**SAMPLING AND ANALYSIS PLAN ADDENDUM
FOR SITE 38 —
BUILDING 71 AND INDUSTRIAL SEWER LINE
(TL 073/C SOUTHWEST TO THE END)
NAVAL AIR STATION
PENSACOLA, FLORIDA**

**SOUTHDIV-CONTRACT NUMBER:
N62467-89-D-0318
CTO-058**

**Prepared for:
NAVAL SUPPORT ACTIVITY
NAVAL AIR STATION
PENSACOLA, FLORIDA**

July 27, 1993

FIGURE A-1
 PROPOSED SOIL BORING AND MONITORING WELL LOCATIONS

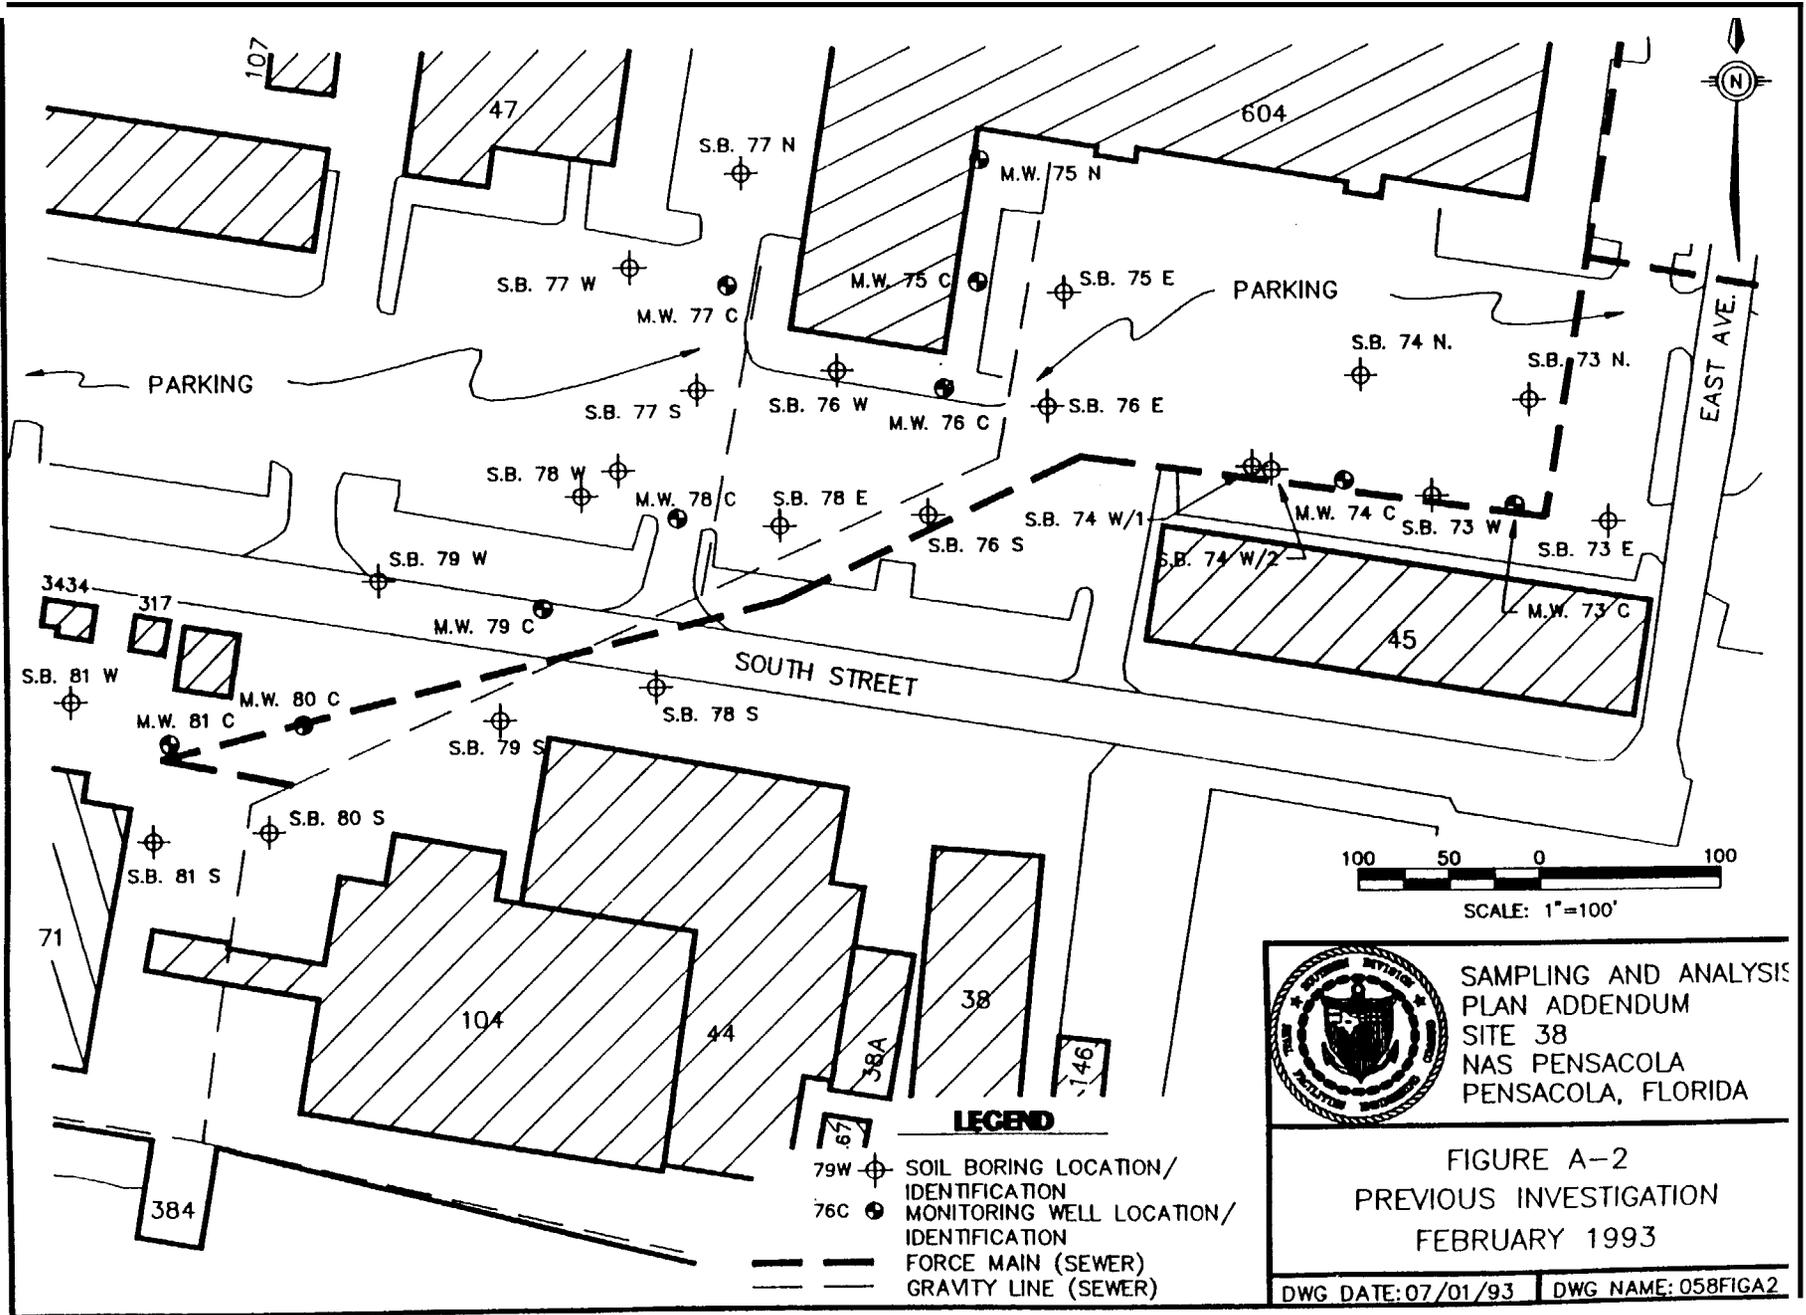
manholes where leakage may have **occurred**, will be placed along the length of the industrial sewer line. The soil boring locations **are** illustrated **in** Figure A-1. Boring depths are based on the depth to water measurements collected during the February 1993 E/A&H investigation. Soil samples will be collected from 0 to 1-foot depth **and** at 2-foot intervals to the water table in areas of less than 5 feet to the water table. Soil samples will be collected from 0 to 1-foot depth and at 5-foot intervals (4-6', 9-11., etc.) to the water table in **areas** greater than 5 feet to the water table. These borings will be used to locate industrial sewer line leaks which may have contaminated soil above the water table. Boring locations **are** tentative and may change based on field observation or video and smoke test results.

Five monitoring wells will be completed along the industrial sewer line, **as** shown in Figure A-1. Two shallow depth monitoring wells (approximately 15 feet deep) **and** three intermediate depth monitoring wells (approximately 40 feet deep, to the top of **an** underlying confining clay layer) will be completed. Analytical results from industrial sewer line monitoring wells will be used **to** delineate any impact by the sewer line. Well locations are tentative and may change based on field observation or video and smoke test results.

Twelve ABB monitoring wells (11 shallow and 1 intermediate) near the IWTP sewer line between Buildings 604 and 45 (Figure A-1) will be redeveloped and sampled to determine the impact on groundwater **from** a former leaking underground storage tank (**UST**) at Building 604 or **the** IWTP sewer line. Preliminary work completed during the **UST** program **has** identified high concentrations of 1,2-dichloroethene, tetrachloroethene, trichloroethene, vinyl chloride, and cadmium in the groundwater.
